Access Compliance Report

Public Rights-of-Way

(Curb Ramps)

Intersection ID: 22200	Main Street: S_TRYON_ST	Cross Street: JOHN_PRICE_RD	Location: SW
ADA ID: 77191FF121F0	Ramp Type: Perp	Initial Pass/Fail: Fail	Overall Compliance: No
			Severity Score: 21.25

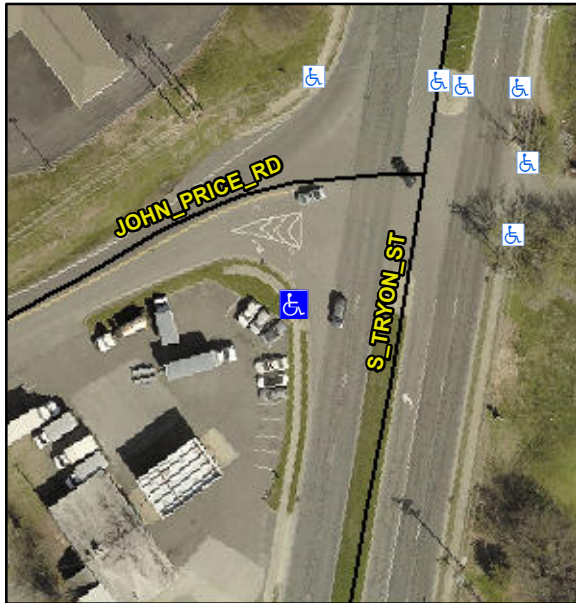
R304.5.1, R304.2.2

Compliance	Description	Data	Compliance	Description	Data
N/A	Ramp Length (in)	88.0	No	Ramp Slope (%)	8.6
No	Ramp Width (in)	38.0	Yes	Ramp XSlope (%)	1.0
N/A	Flare Type LT	N/A	N/A	Flare Type RT	N/A
N/A	Flare Slope LT (%)	N/A	N/A	Flare Slope RT (%)	N/A
N/A	Flare Traversable LT?	N/A	N/A	Flare Traversable RT?	N/A
N/A	Landing Length (in)	N/A	N/A	DWS Provided?	N/A
N/A	Landing Width (in)	N/A	N/A	DWS Contrast?	N/A
N/A	Landing Slope (%)	N/A	N/A	DWS Length (in)	N/A
N/A	Landing X Slope (%)	N/A	N/A	DWS Full Width?	N/A
N/A	Landing Curb? (Y/N)	N/A	N/A	DWS Offset (in)	N/A
N/A	Shared Landing?	N/A			
N/A	Gutter Ponding?	N/A	N/A	Gutter Slope (%)	N/A
N/A	Gutter Lip Ht (in)	N/A	N/A	Gutter X Slope (%)	N/A
N/A	Painted X Walk1?	No	N/A	Painted X Walk2?	N/A
	X Walk 1 Direction	To E		X Walk 2 Direction	N/A
N/A	X Walk 1 Width (in)	N/A	N/A	X Walk 2 Width (in)	N/A
	X Walk 1 Slope (%)	1.3		X Walk 2 Slope (%)	N/A
	X Walk 1 X Slope (%)	0.9		X Walk 2 X Slope (%)	N/A

Remove & Replace Entire Ramp.
